SERVICE BULLETIN

75A-4

**SUBJECT: "S" METER SENSITIVITY POTENTIOMETER AND
ZERO POTENTIOMETER REPLACEMENT**

**DRAWING - INSTALLATION
S METER - POT**

TOP VIEW OF FRONT PANEL

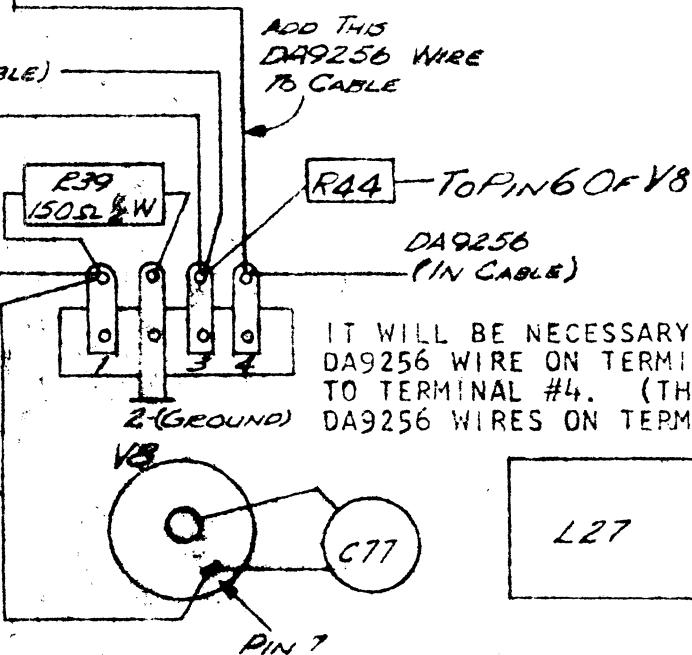
9. The meter should be wired as shown in the top view of the front panel on installation drawing 542 4452 002.
10. Rewire the terminal strip adjacent to tube V8 as shown in installation drawing 542 4452 002.

IT WILL BE NECESSARY TO DISCONNECT
DA9256 WIRE ON TERMINAL #3 & CONNECT
TO TERMINAL #4. (THIS WILL PUT 2
DA9256 WIRES ON TERMINAL #4.)

UNDER CHASSIS
VIEW

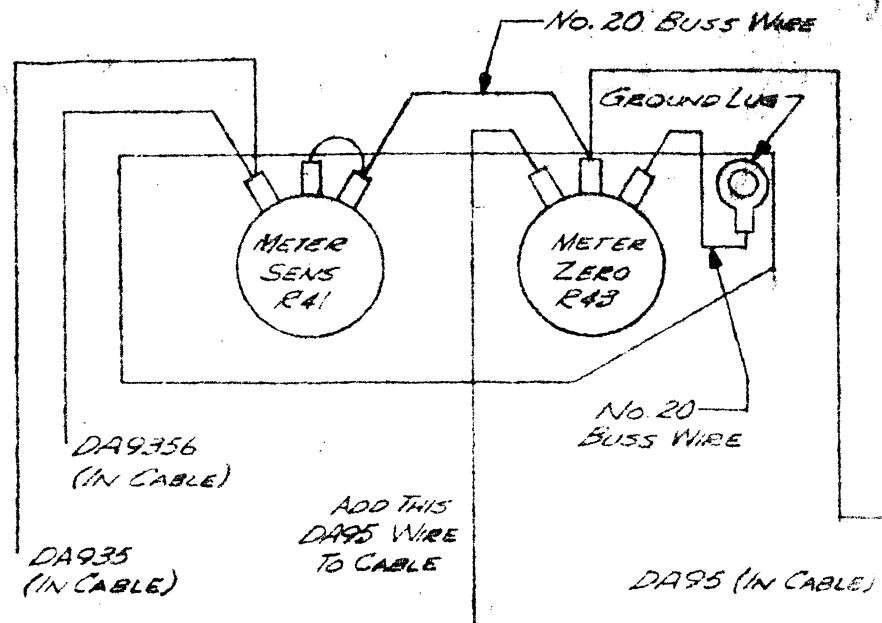
ADD NO. 20
BUSS WIRE
FROM TERMINAL
1 TO PIN 7
OF VB

10. REWIRE TERMINAL STRIP AS SHOWN.

9. METER SHOULD BE WIRED AS SHOWN IN TOP VIEW OF FRONT PANEL.
8. CONNECT DA9356 WIRE WHICH FORMERLY WENT TO HOT TERMINAL OF METER SENSITIVITY POT TO CLOCKWISE TERMINAL OF NEW METER SENSITIVITY POT.
7. REMOVE SHORT DA935 WIRE FROM CABLE WHICH CONNECTS METER ZERO POT TO METER SENSITIVITY POT.
6. DELETE R40 WHICH IS ACROSS METER.
5. MOVE R39.
4. REMOVE R42.
3. MOUNT POTS P/N 750 327 00 TO PLATE P/N 542 3150 002 AND MOUNT ASSEMBLY TO SPACERS.
2. MOUNT 6-32 X 1-1/4 SPACERS (P/N 540 9225 003) IN HOLES FORMERLY USED FOR MOUNTING ZERO SET SENSITIVITY POTS.
1. REMOVE METER SENSITIVITY & METER ZERO POTS.
